City of Kodiak
Baranof Park Improvements; Ice Rink PN 19-03/9018
Addendum No. 4
April 21, 2022

The following change(s) and/or clarification(s) are made to the Plan and Specification Documents of Invitation to Bid for the Baranof Park Improvements; Ice Rink PN 19-03/9018:

1 SITE PLAN-CONSTRUCTION
1" = 30'-0"

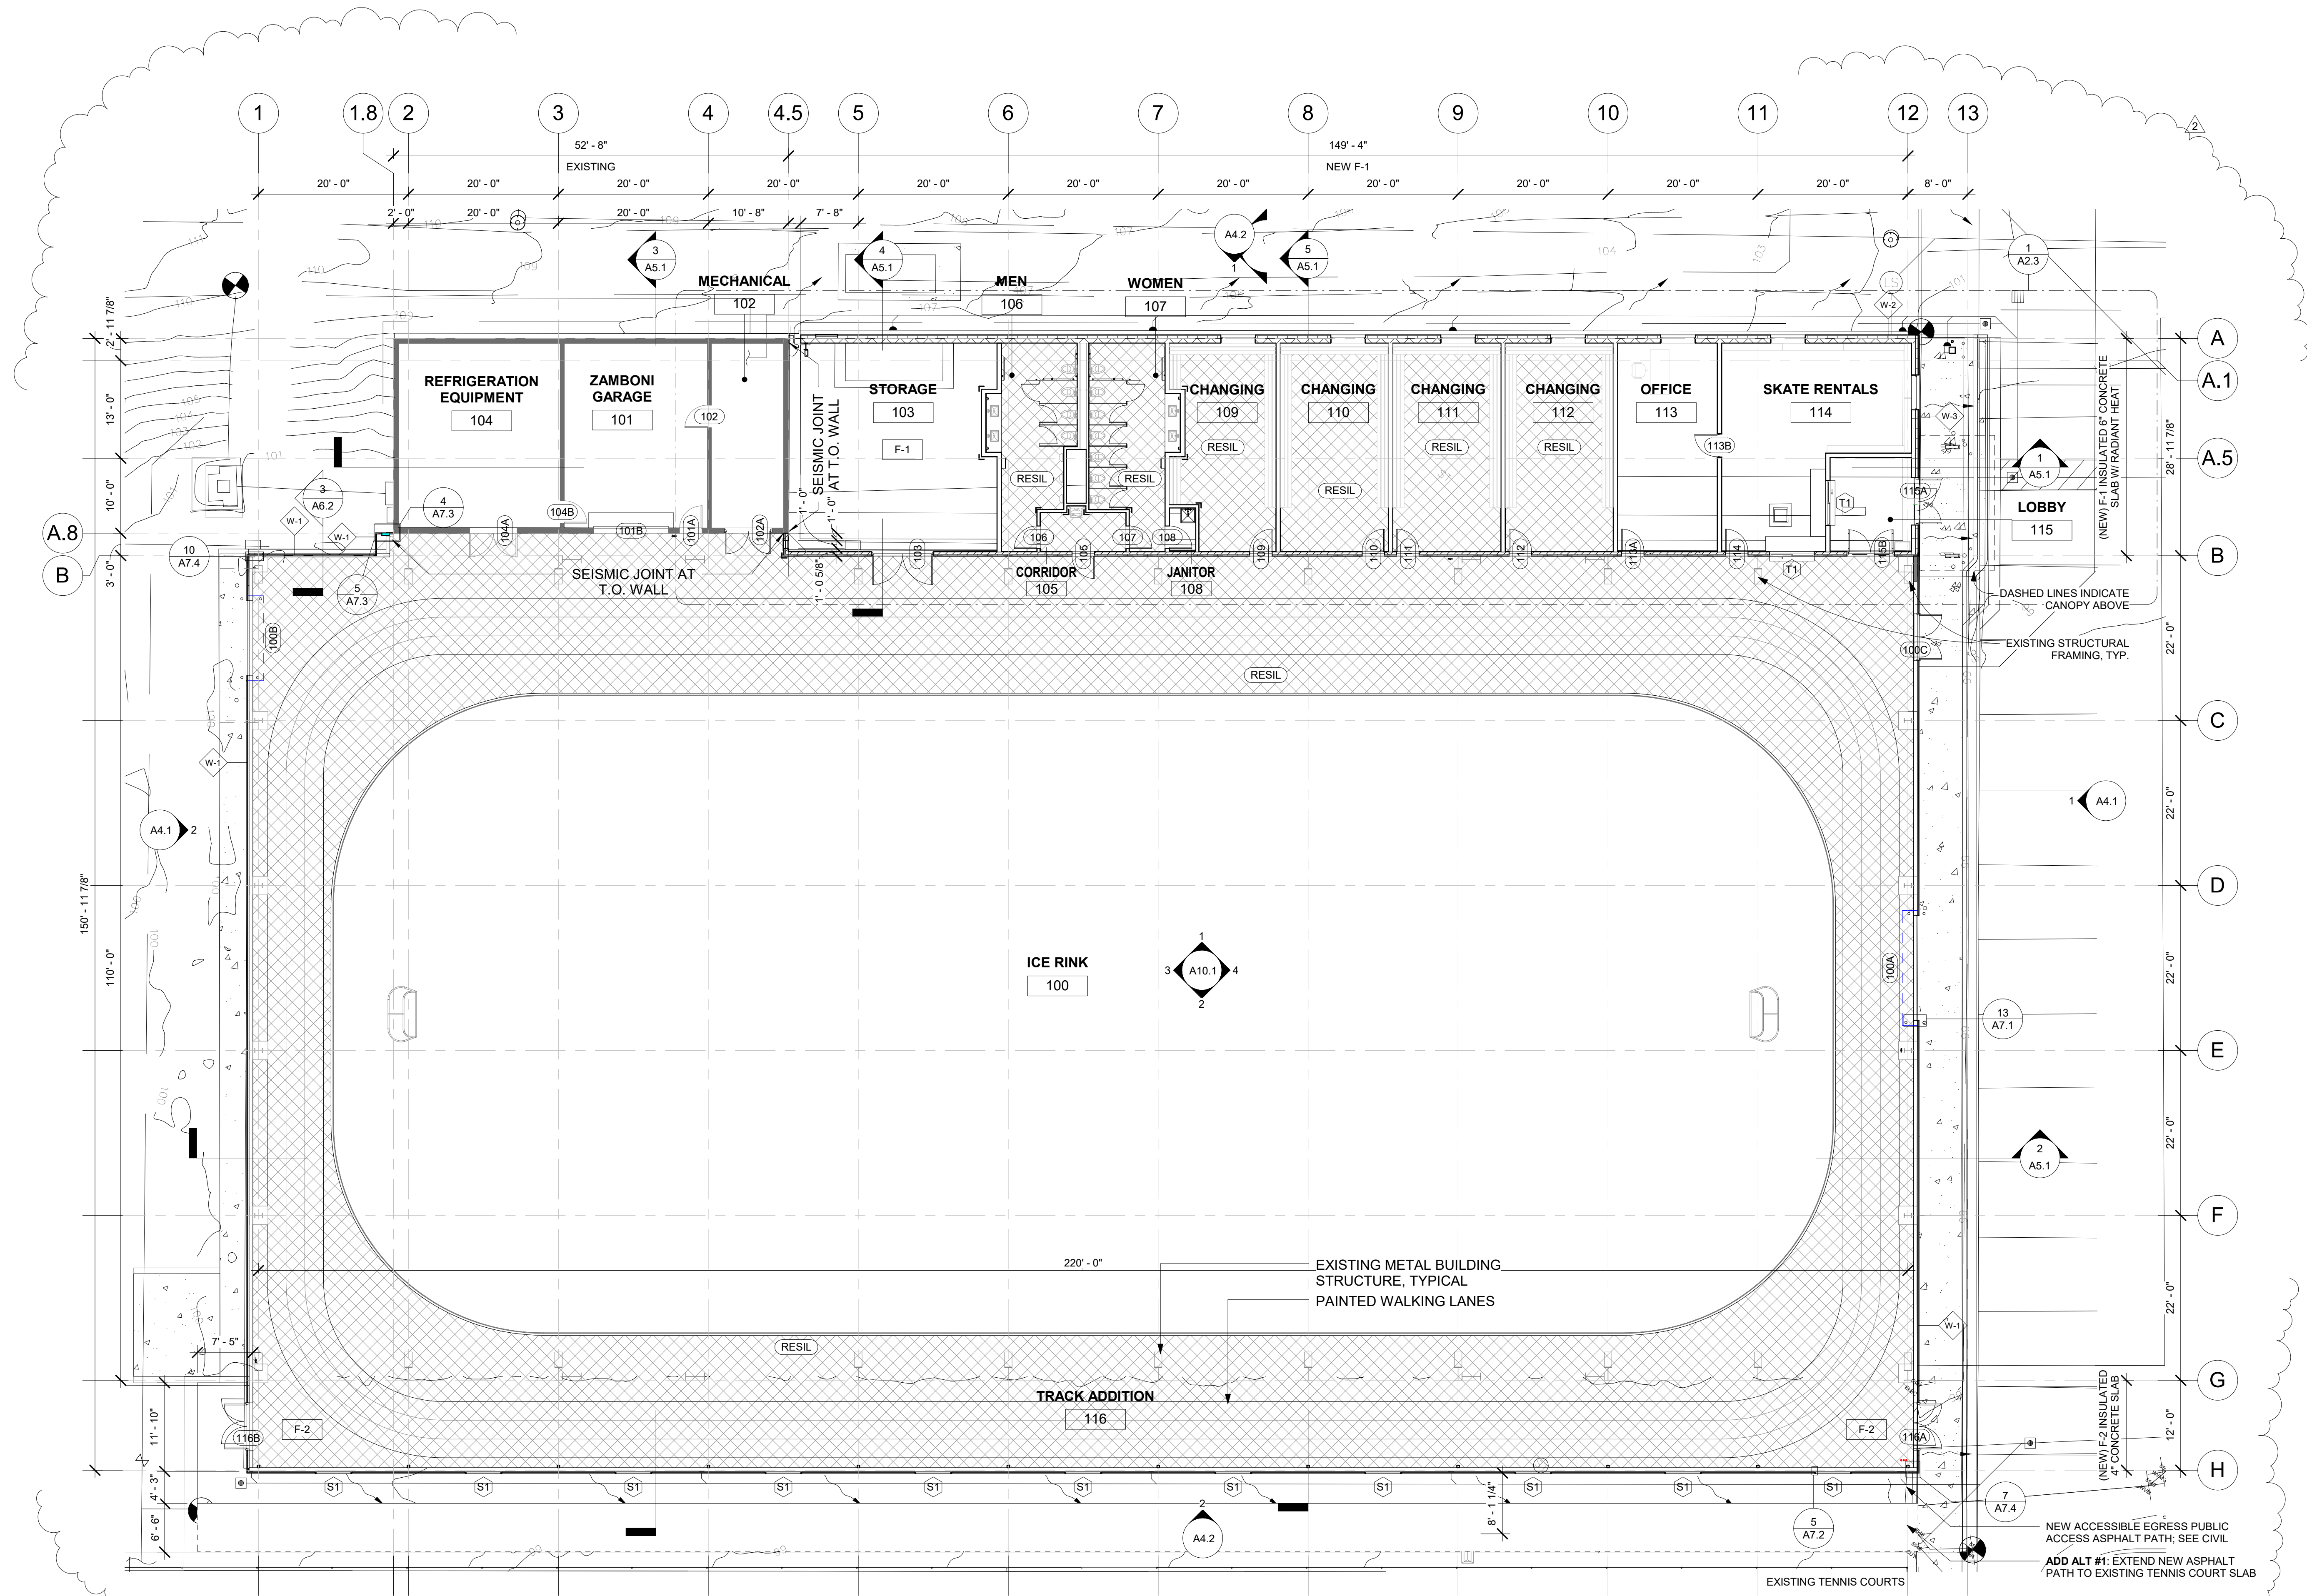
Item No. 1 : Revise Sheet A2.1 – SITE PLAN

Revise site plan to include adjacent lot for contractor Field Office / Parking / Laydown Area per attached drawing. Add area hatch to identify area of the building and site to be occupied / used by the owner / public from October 1, 2022 to March 26, 2023 per attached drawing.

1 LIGHTING REMODEL PLAN
3/32" = 1'-0"

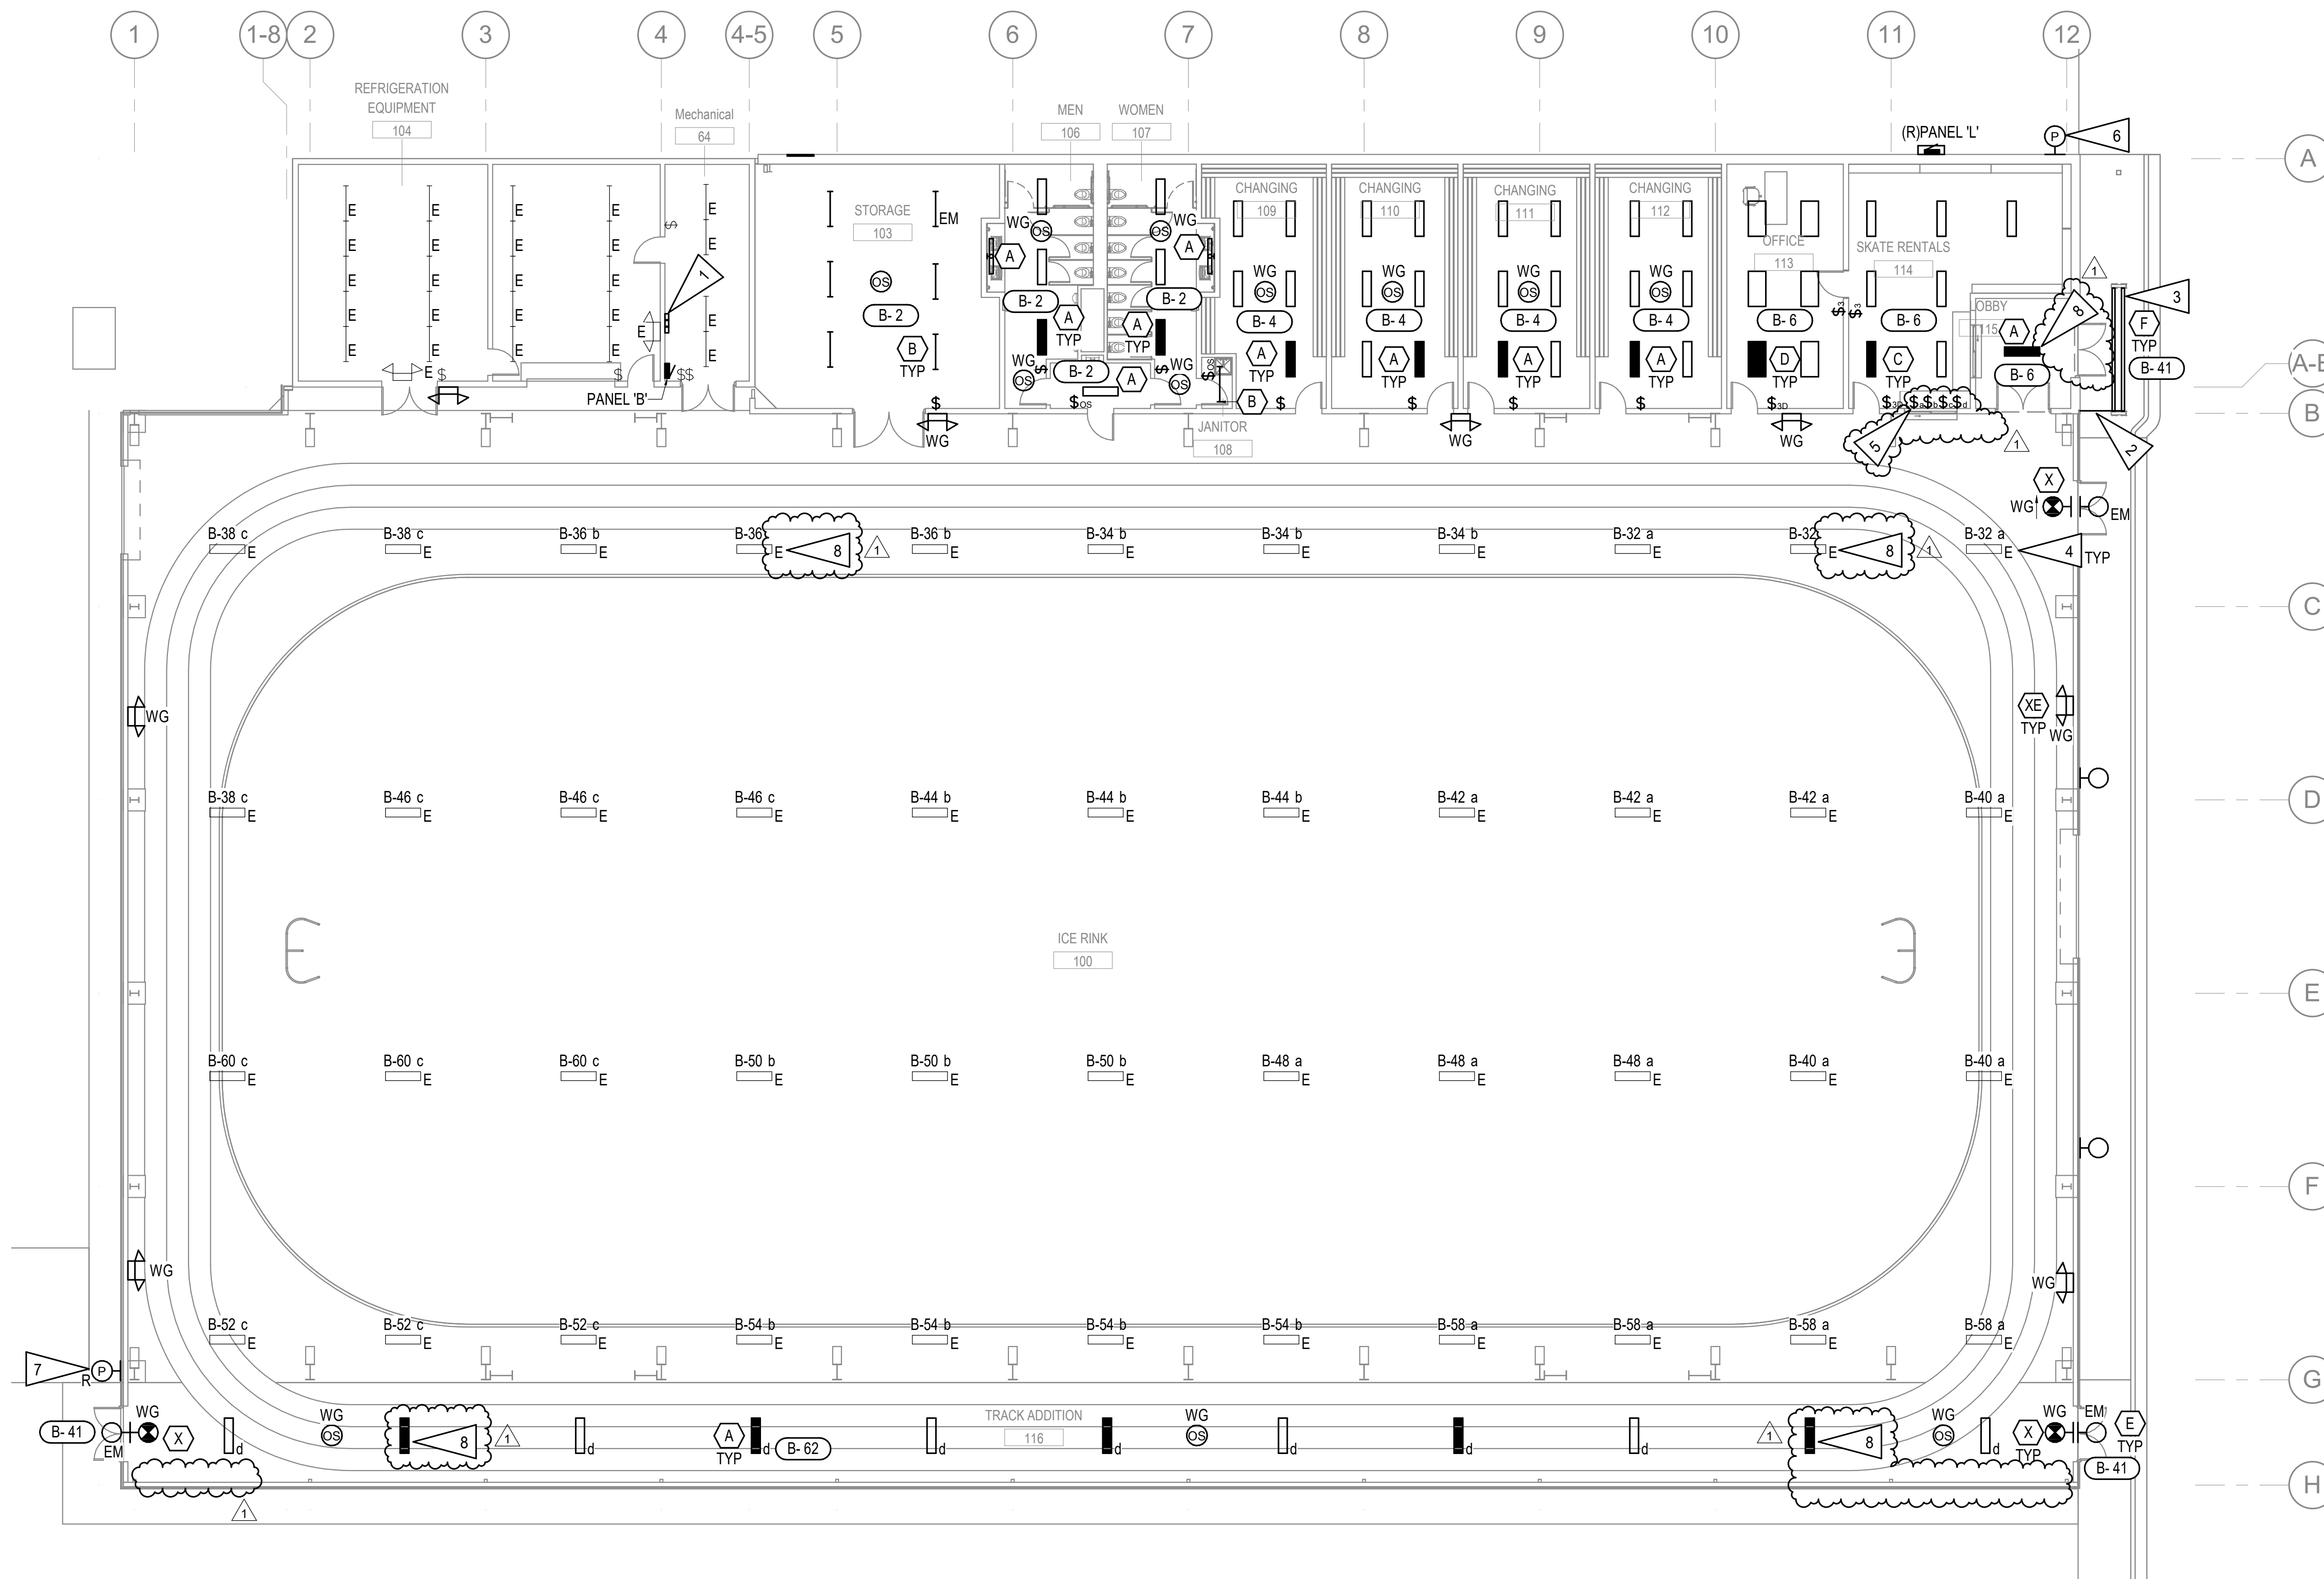
- a) Question: Are they sure they want to put 3 way and 4 ways switches to control the ice rink lights. It might be better to leave a couple lights on and put switches in office?

Answer: Please see attached drawing revisions to the lighting sheets (sheets E2.1 and E6.1) to accommodate the deletion of the 3-way and 4-way switches, relocation of one bank of switches into the Skate Rental Room 118, the deletion of occupancy sensors in the entry area, and the night lights in the rink area.
